128 Duntroon St
 Hurlstone Park

Statement of Environmental Effects for a DA Modification

This document forms part of a Application to Modify DA-656/2025 (approved 21.08.25) for alterations and additions to a detached single dwelling at 128 Duntroon St, Hurlstone Park.

These changes have been numbered in the accompanying architectural drawings, and extract of which is found below.

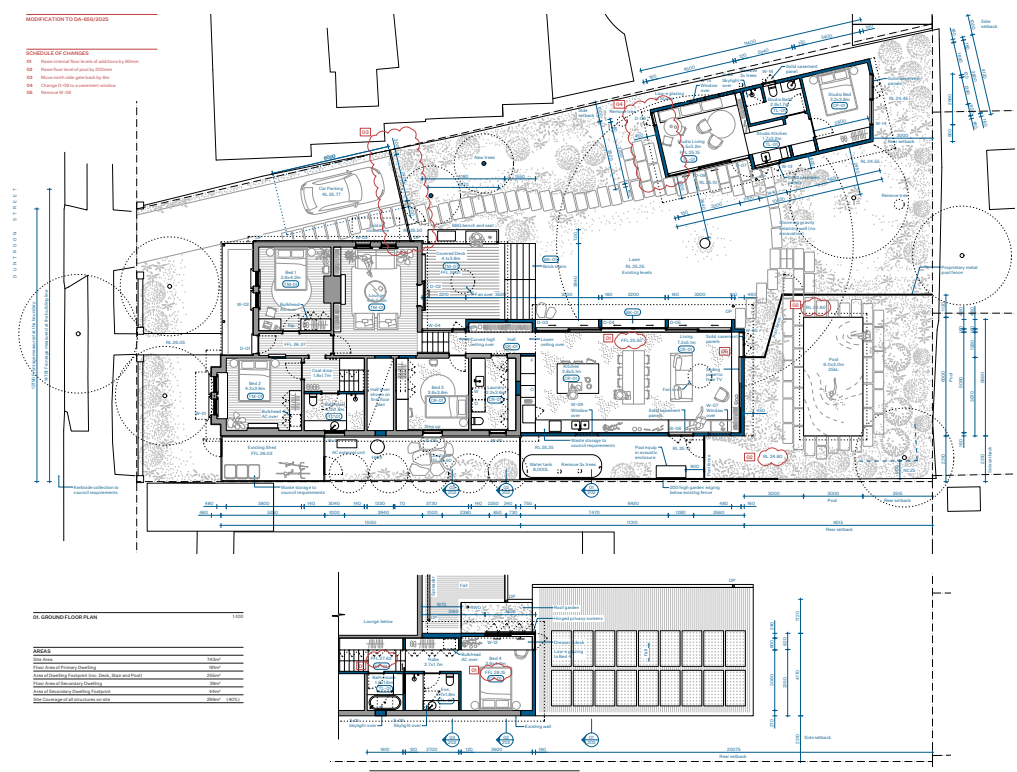
Upon developing the structural design of the project, it was discovered that a saving could be made by raising the internal floor levels of the proposal by 80mm. This can be done without changing the external form of the dwelling, and so presents no external changes to the built form. Even so, this is being included in the modification to satisfy condition 16 of the approval - which requires strict adherence to both internal and external floor levels.

A recent geotechnical report has found that the area where the pool is proposed contains rock at approximately 1.2m depth. The pool area is proposed to be raised by 200mm to limit the excavation into rock. The proposal will include a shallow batter to allow levels at boundary fences to be retained.

The north side fence is proposed to be moved to behind the parking area. This allows for better access and parking separation for primary and secondary dwellings. This proposal is located within a heritage conservation area, and as such the location of this fence will affect the streetscape appearance.

The large sliding door originally proposed to the west end of the studio is proposed to change to a smaller casement window. This change increases privacy between the house and the studio and reduces western sun and heat load. An amended basix certificate has been prepared including this change.

The low window at the eastern end of the living room is proposed to be removed as a cost saving. An amended basix certificate has been prepared including this change.

Internal floor level changes are minor - only 80mm - and do not result in any changes to the external form of the proposal. Importantly, there is no change to the privacy strategies employed by the original proposal, and the heritage impacts are unaffected. First floor ceiling levels are also increased 80mm, and as such the ceiling heights are not affected and minimums are maintained.

The proposed increase to the pool level is also minor at only 200mm. The site topography is being modified slightly in this area - to replace an existing small retaining wall that has failed. This increase in height actually makes this step lesser and so more closely retains the natural topography of the surrounding area. A natural batter is proposed around the pool to meet the existing levels at the boundary, so no works within 900mm of the boundary are proposed.

The existing side gate is currently aligned to the front wall of the dwelling. As this is not in line with the outcomes of the heritage conservation area, the original DA proposed moving it back 1m. This proposal moves the gate back 7m from the existing location, to not only provide relief from the existing dwelling, but also to ensure that parked cars are found at least 1m behind the front wall of the dwelling. This aligns to the aims of the DCP and the heritage conservation area. The construction and material palette of the proposed gate is unchanged.

The west end of the studio is visible from the street, and so impacts the site's appearance and contribution to the streetscape and heritage conservation area. However, this door is over 26m from the front boundary and is lower than the street. It is thus likely to be blocked behind the side gate and not visible to passers by. The proposed change does not impact the bulk or scale of the studio.

This window was proposed at the rear of the dwelling and was not visible from the street. It was at floor level and did not overlook any neighbours. It was not providing minimum requirements for natural light or ventilation, and so its removal is not causing any impacts.
